From: [REDACTED]
Sent: 27 September 2026 20:48
To: Planning; [REDACTED]
Cc: [REDACTED]
Subject: Considerations for Planning Application DC/26/0954

Objection planning application DC/26/0954 points 1 / 6 below -

PROJECT
Proposed Development of Land
off Athelstan Way, Horsham
CLIENT
Mr & Mrs A Brazil
DRAWING
Concept Plan 1

POINT 5 - BOUNDARY OWNERSHIP

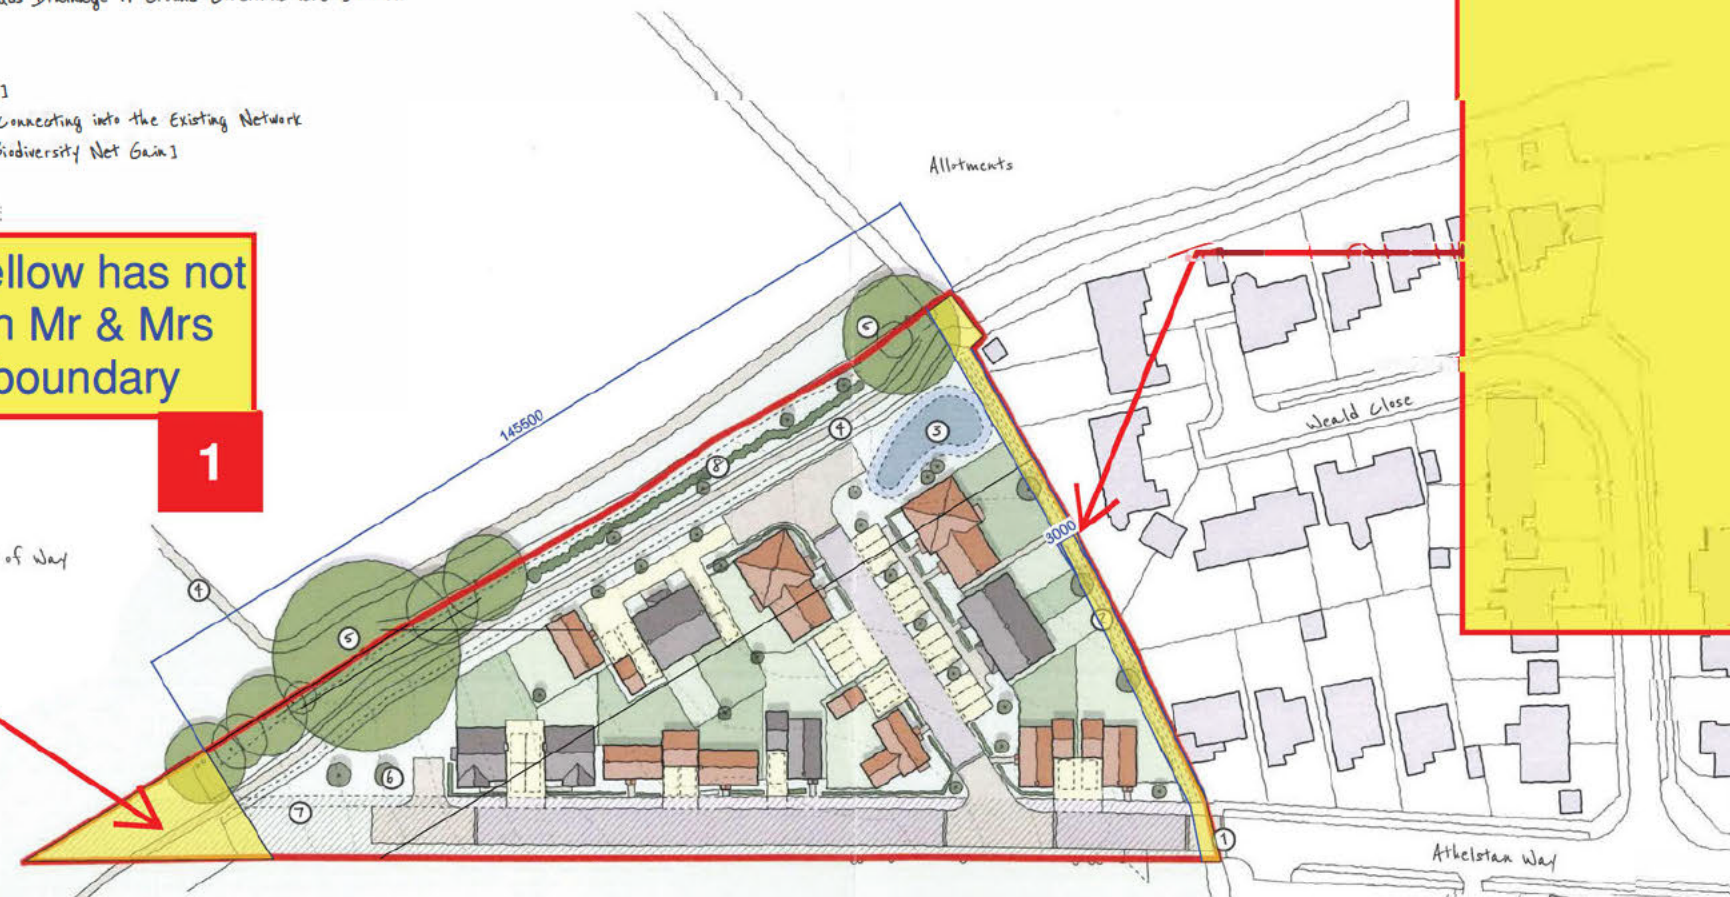
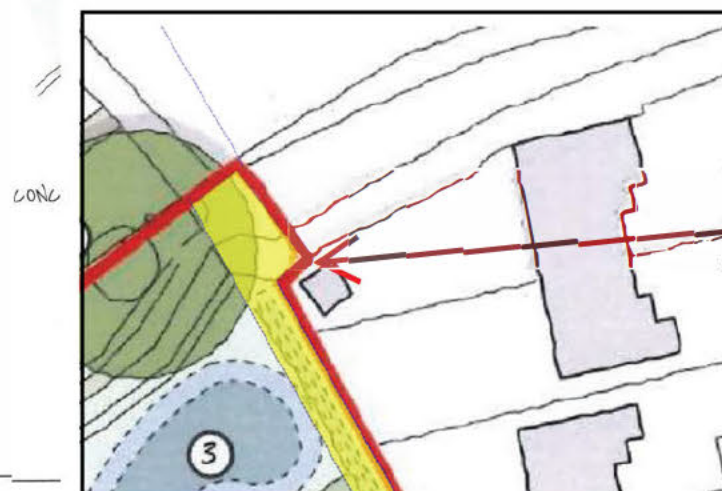
The culvert land (Ref: SX46976) owned by Ideal Homes / Persimmon as marked on the land registry title number SX46976 is not part of Mr and Mrs Brazils land boundary & should not be included in the boundary of their new housing developments. It should be moved 3 metres from the fences of Weald Close / Athelstan Way.

Area marked yellow has not been included in Mr & Mrs as built fenced boundary

Boundary proposed by Mr Brazil as marked with a red line protrudes past the corner of property No29. This is incorrect see OS Map Ref:TQ1829NW
